ADDENDUM NO. 1 TO BID FORMS

**CORONA-NORCO UNIFIED SCHOOL DISTRICT
PURCHASING DEPARTMENT
Bid No. 2023/24-204**

CORONA FUNDAMENTAL INTERMEDIATE SCHOOL MPR MODERNIZATION

SHEET TITLE:
CLASSROOM ROOM 20 -
ENLARGED PLAN & INT
ELEVATIONS

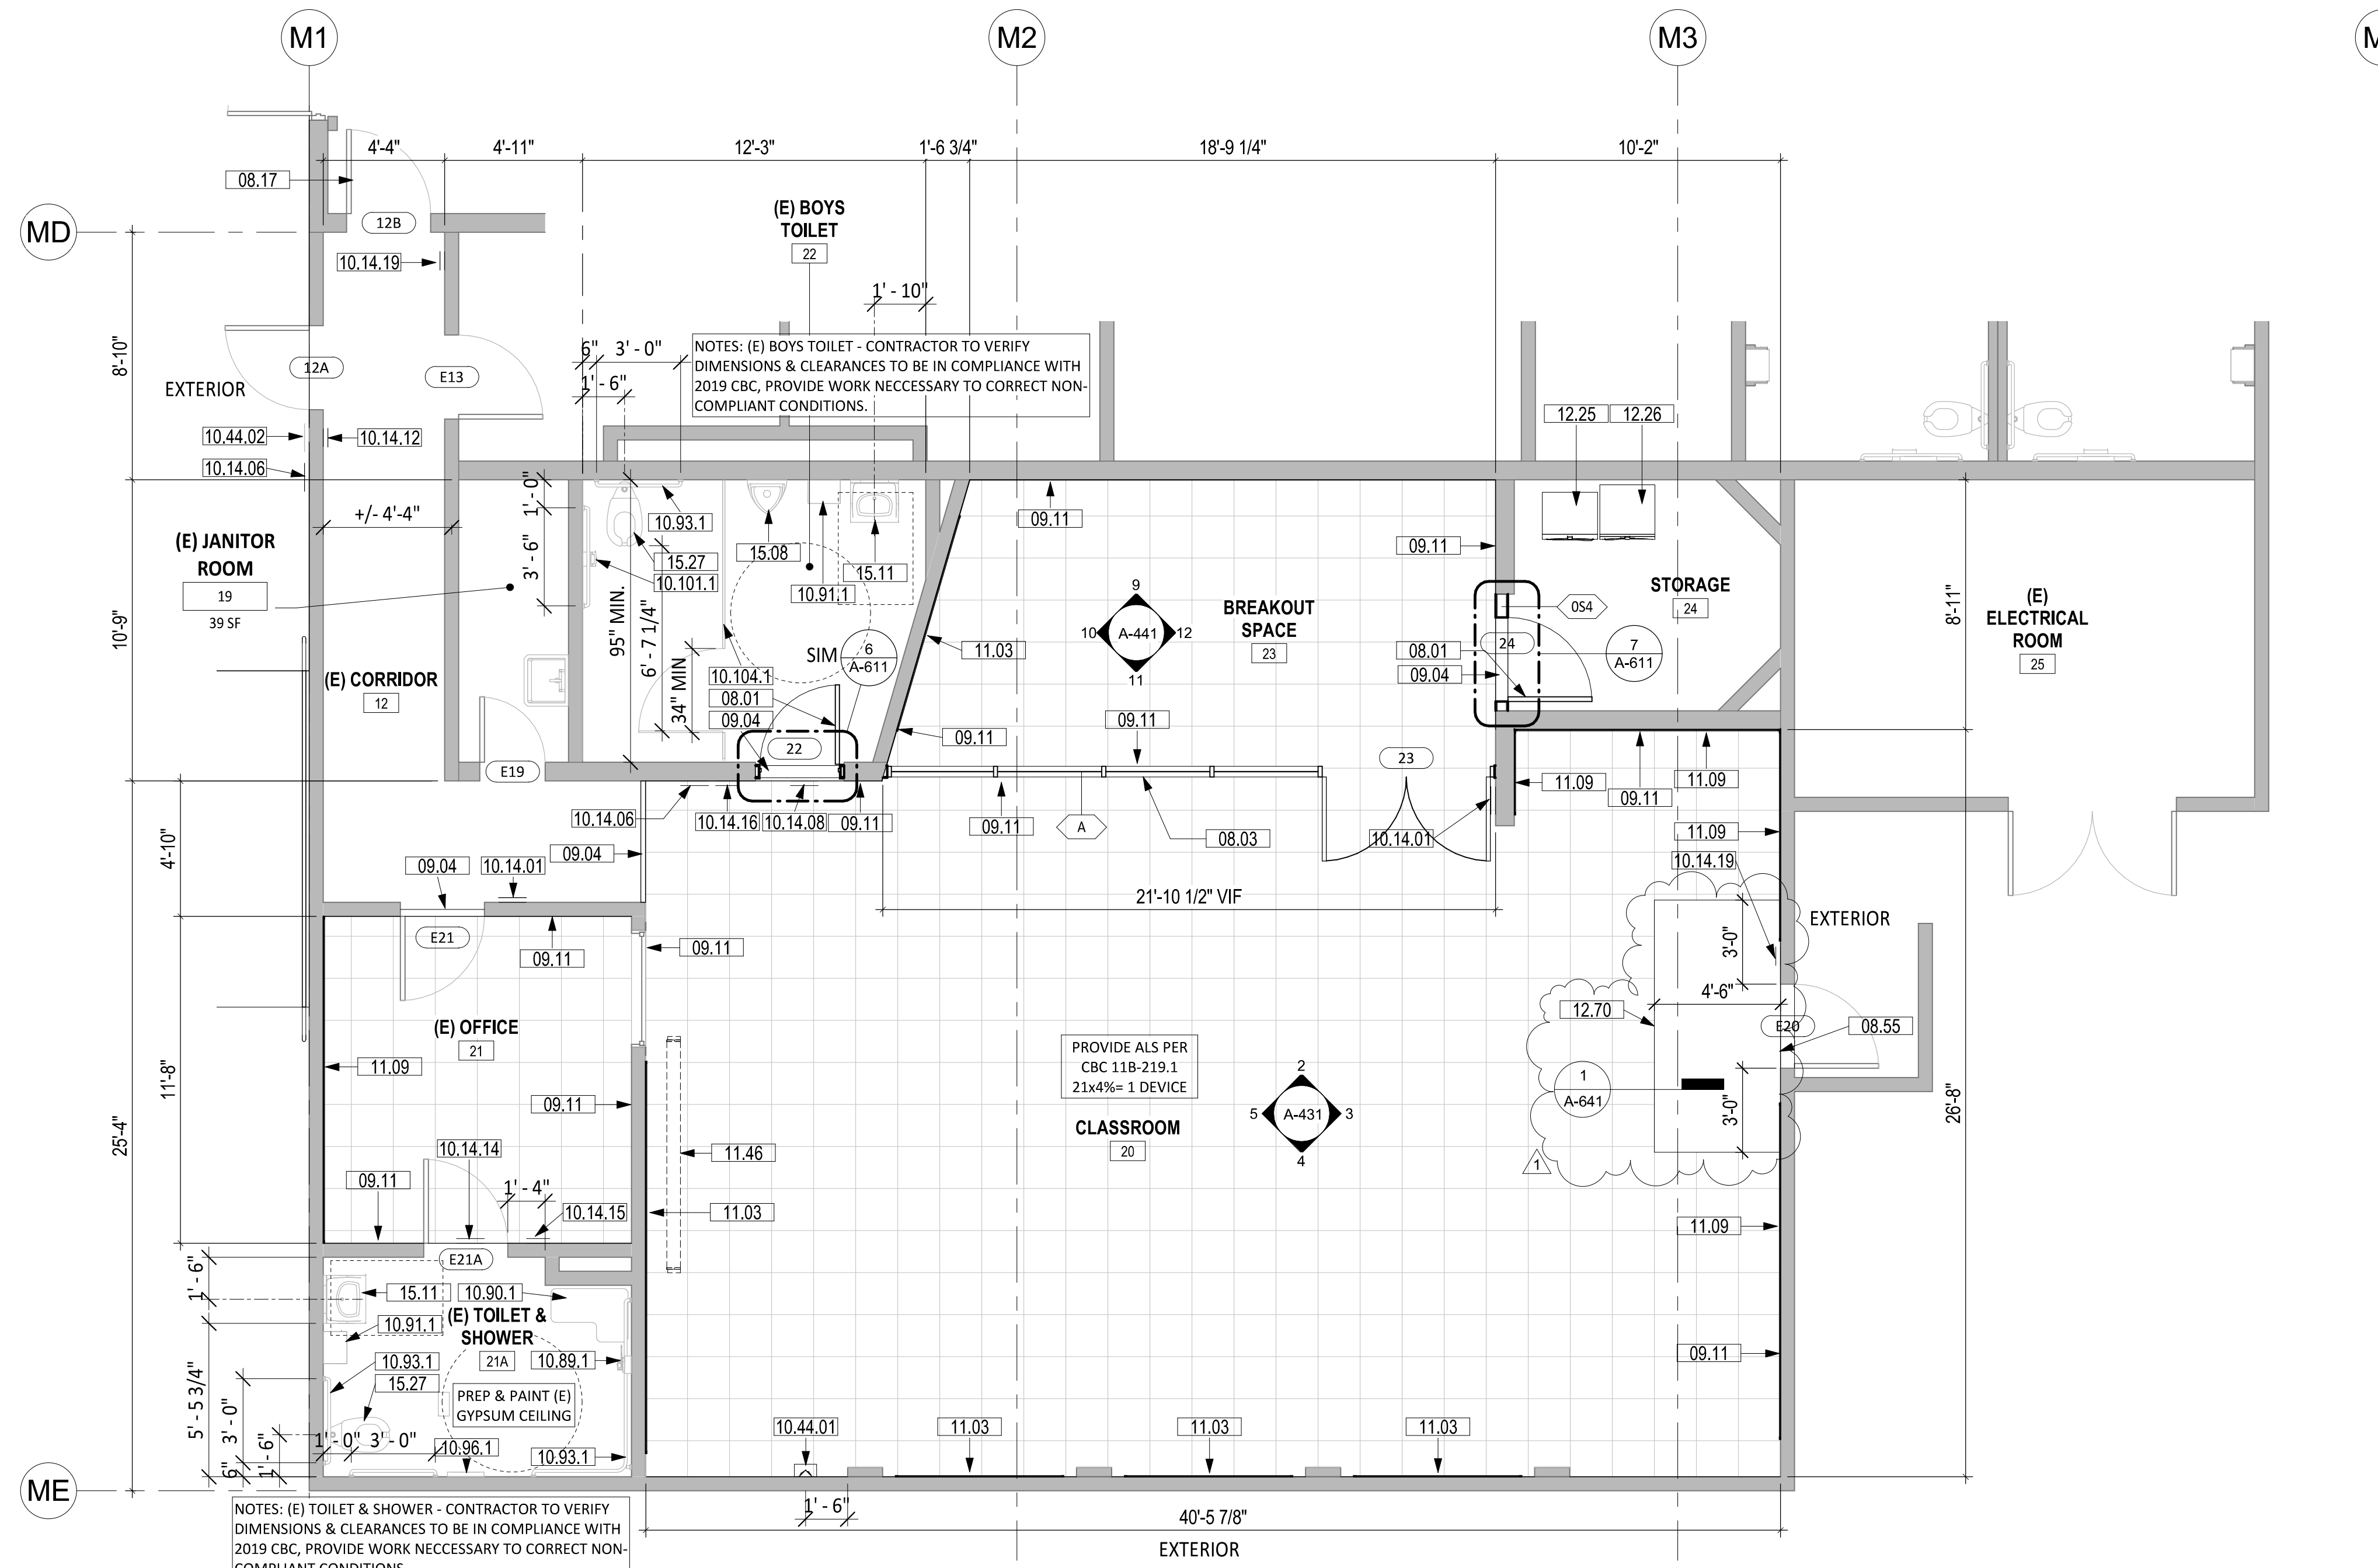
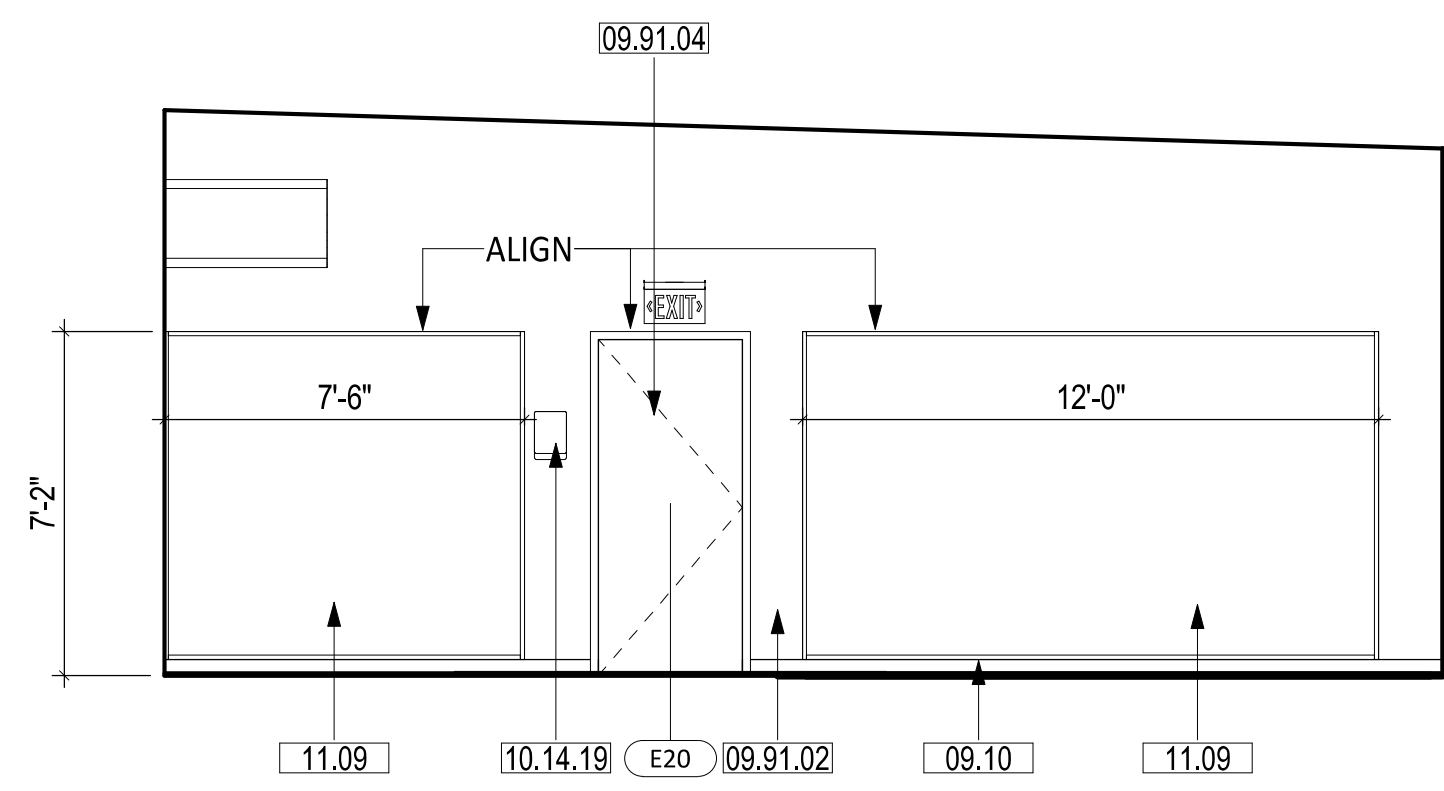
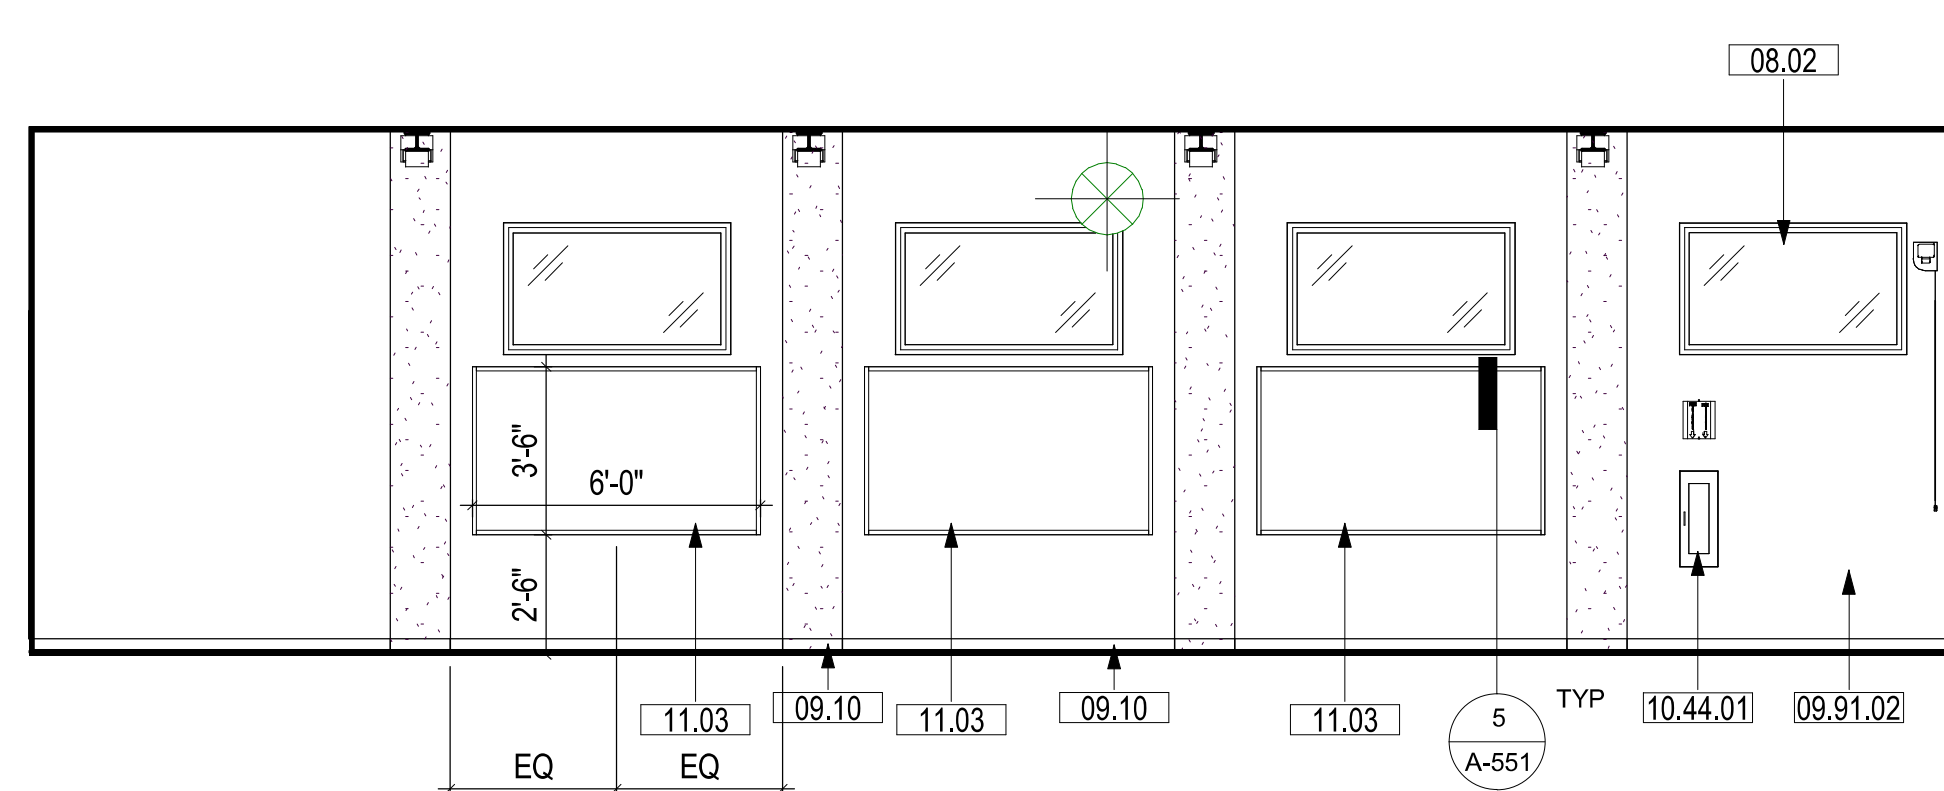
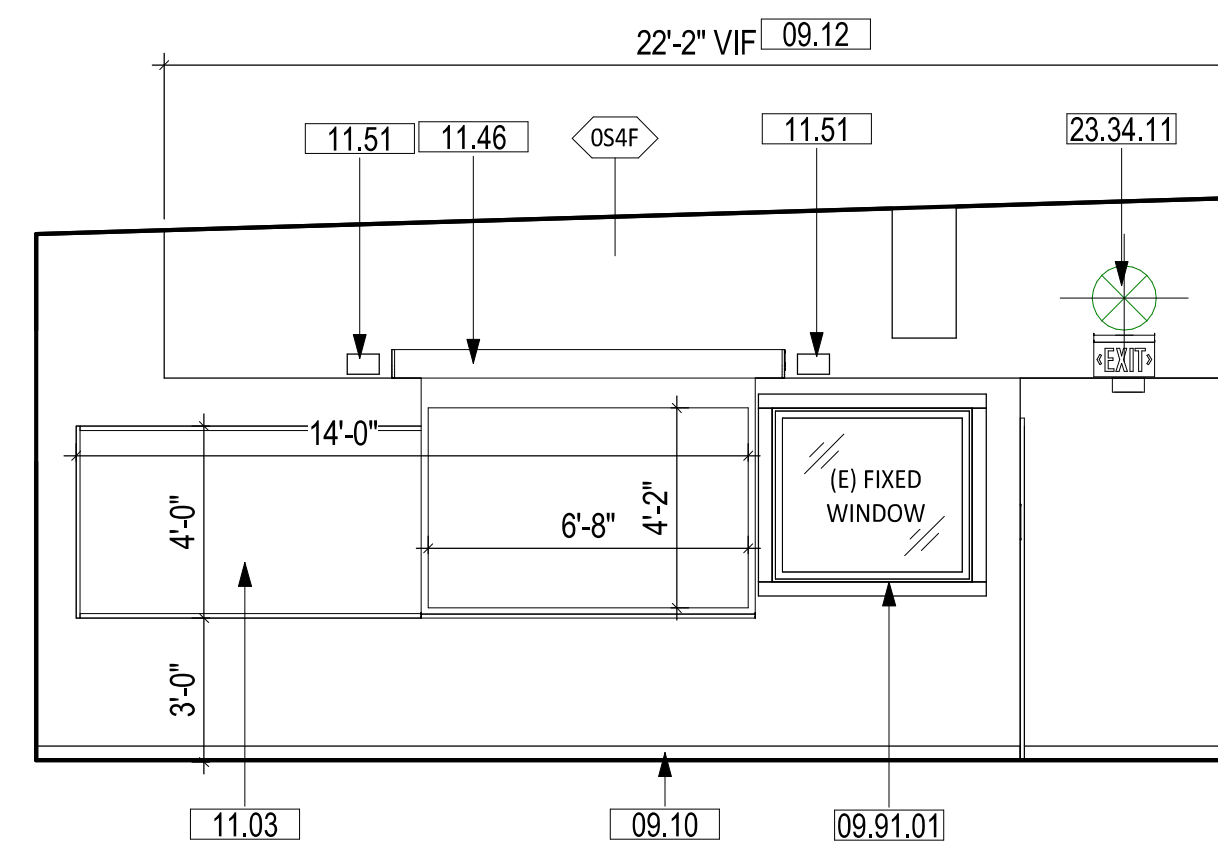
Item No. 1.10
Sheet A-431 - CLASSROOM ROOM 20 - ENLARGED PLAN & INT ELEVATIONS

- Floor mat added and keynoted at Door E20 in Classroom 20
- Keynote 12.70 added for floor mat
